REVISION NOTICE
Bell Helicopter **TEXTRON**
A Subsidiary of Textron Inc.

SUBJECT: **REVISION "A" TO ALERT SERVICE BULLETIN 427-05-12:
CLEVIS ASSEMBLY-HYDRAULIC SERVO ASSEMBLY PART NUMBER
41011300 AND 41011700**

NO. 427-05-12

SUBJECT: CLEVIS ASSEMBLY HYDRAULIC SERVO
ASSEMBLY, PART NUMBER 41011300 AND
41011700

Clevis Assembly
Figure 1

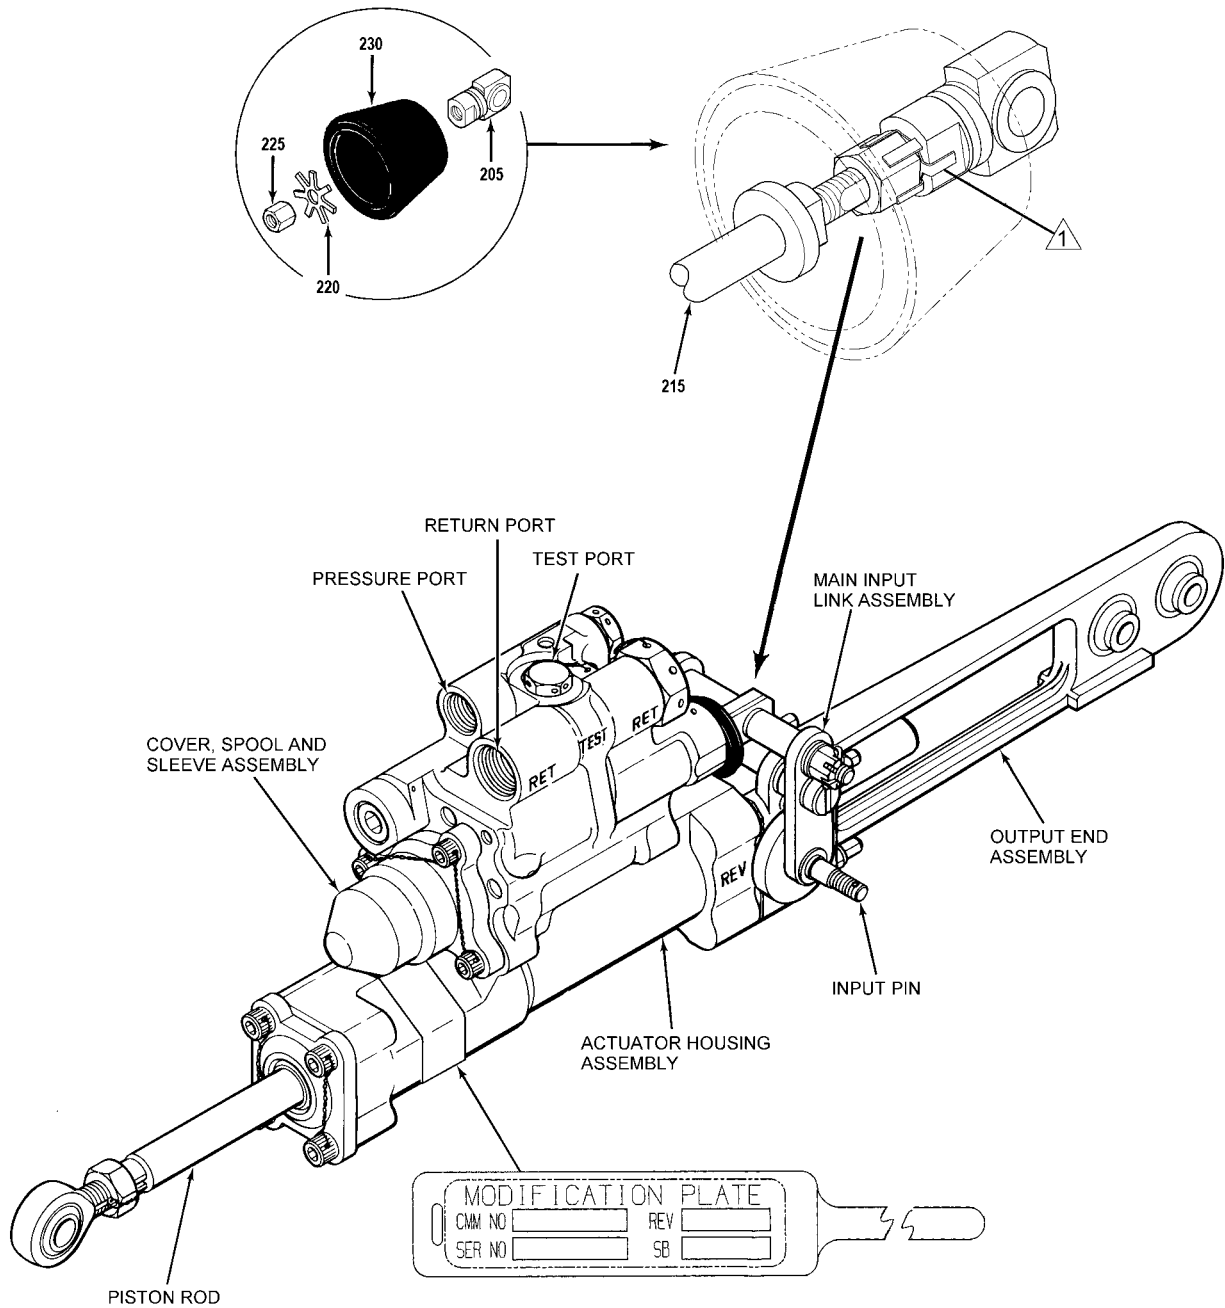
- The HR Textron Customer Service telephone number phone number, is added in Section 1, Step F.
- The compliance in Section 2, Step A, is changed.
- The inspection criteria are clarified in Section 2.
- HR Textron-Authorized Service Centers telephone and fax number are added in Table 1.
- A better graphic view of the proper installation is shown in Figure 1.

HR has discovered the possibility that the shaft (215) (refer to Figure 1) could be loose. The looseness is as a result of lock washer tabs (220), improperly bent over the flat surface of the nut (225) or the flat surface of the clevis assembly (205).

1. Applying hand pressure only, and check if the nut, the shaft or the clevis assembly is turning independently from one another.
2. If the shaft will turn independently to the nut or the clevis assembly, prior to the next flight, the actuator shall be removed from service and forwarded to HR Textron or one of the HR Textron Service Centers listed in Table 1. Check step 1.F. for condition.

3. If the shaft is not turning independently from the nut or the clevis assembly proceed with step 2.B.4.
4. Check if at least one tab of the lock washer is bent flush against one of the nut flat surface and if at least one tab of the lock washer is bent flush against one of the two flat surfaces of the clevis assembly. Lock washer tab must also be in line with the flat surface of the nut and clevis assembly. If the lock washer tabs are not bent flush against the nut and clevis assembly or are not in line with the flats, proceed with the following steps.

5. If the lock washer tabs are not bent flush against the nut or clevis assembly flat surface, use needle-nosed pliers and make sure the lock washer tab is flush against nut or the flat surface of the clevis assembly.

6. If the lock washer tab is on the edge or not aligned with a flat surface (nut or clevis assembly). Within the next 300 hours, but not later than April 30, 2006, the actuator shall be removed from service and forwarded to HR Textron or one of the HR Textron Service Centers listed in Table 1. Check step 1.F. for condition.

Clevis Assembly
 Figure 1

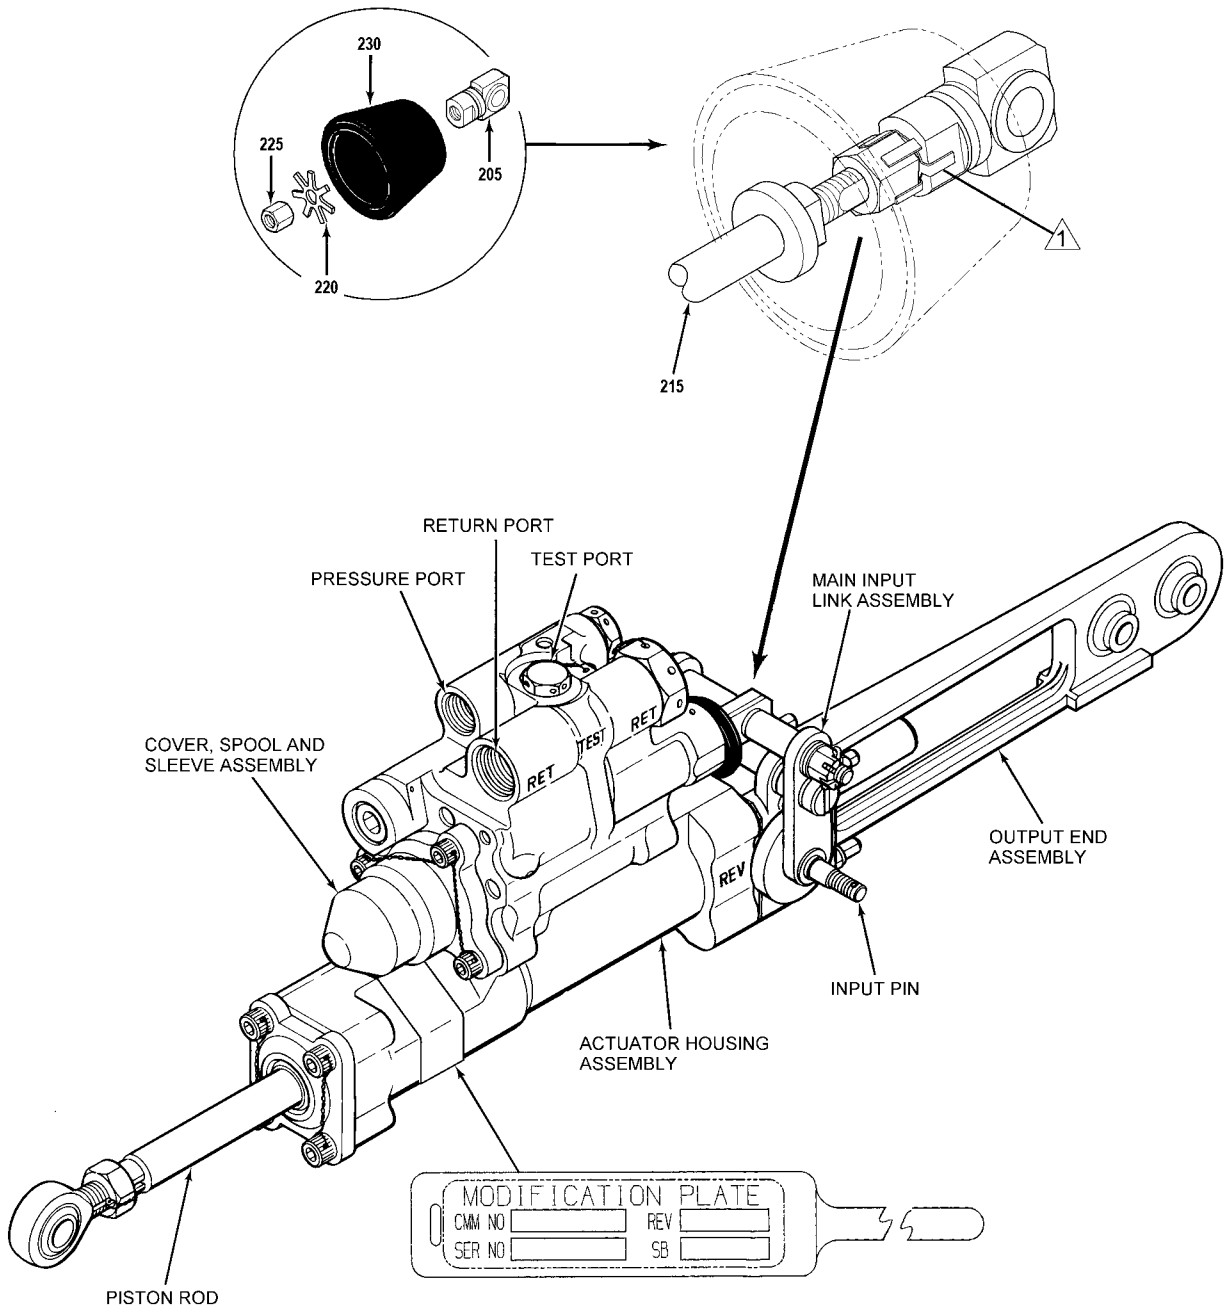
HR has discovered the possibility that the shaft (215) (refer to Figure 1) could be loose. The looseness is as a result of lock washer tabs (220), improperly bent over the flat surface of the nut (225) or the flat surface of the clevis assembly (205).

1. Applying hand pressure only, and check if the nut, the shaft or the clevis assembly is turning independently from one another.
2. If the shaft will turn independently to the nut or the clevis assembly, prior to the next flight, the actuator shall be removed from service and forwarded to HR Textron or one of the HR Textron Service Centers listed in Table 1. Check step 1.F. for condition.

3. If the shaft is not turning independently from the nut or the clevis assembly proceed with step 2.B.4.
4. Check if at least one tab of the lock washer is bent flush against one of the nut flat surface and if at least one tab of the lock washer is bent flush against one of the two flat surfaces of the clevis assembly. Lock washer tab must also be in line with the flat surface of the nut and clevis assembly. If the lock washer tabs are not bent flush against the nut and clevis assembly or are not in line with the flats, proceed with the following steps.

5. If the lock washer tabs are not bent flush against the nut or clevis assembly flat surface, use needle-nosed pliers and make sure the lock washer tab is flush against nut or the flat surface of the clevis assembly.

6. If the lock washer tab is on the edge or not aligned with a flat surface (nut or clevis assembly). Within the next 300 hours, but not later than April 30, 2006, the actuator shall be removed from service and forwarded to HR Textron or one of the HR Textron Service Centers listed in Table 1. Check step 1.F. for condition.

- △ ACCEPTABLE CONDITION
 A MINIMUM OF ONE TAB SHALL BE IN LINE AND BENT FLUSH WITH THE NUT FLAT SURFACE AND A MINIMUM OF ONE TAB SHALL BE IN LINE AND BENT FLUSH WITH THE CLEVIS ASSEMBLY FLAT SURFACE
